**Specification change of indication for MCCB, ELCB and ACB**

We would like to inform that we will change the specification of indication for MCCB, ELCB and ACB.

Before	After
<p>Ex.) NF125-SV 4P</p>  <p>IT Mark</p>

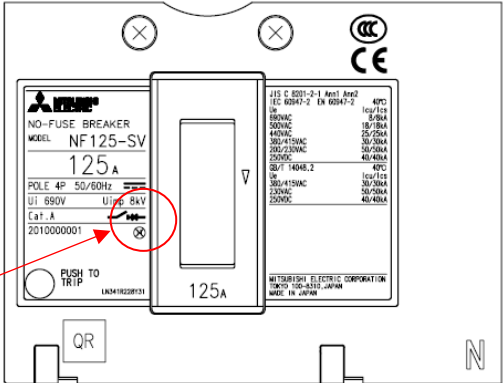
To change symbol of non-IT (ungrounded or impedance grounding) system on main body.

In accordance with the change from IEC60947-2 Ed.4.2 to Ed.5.1, IT × symbol has been changed.
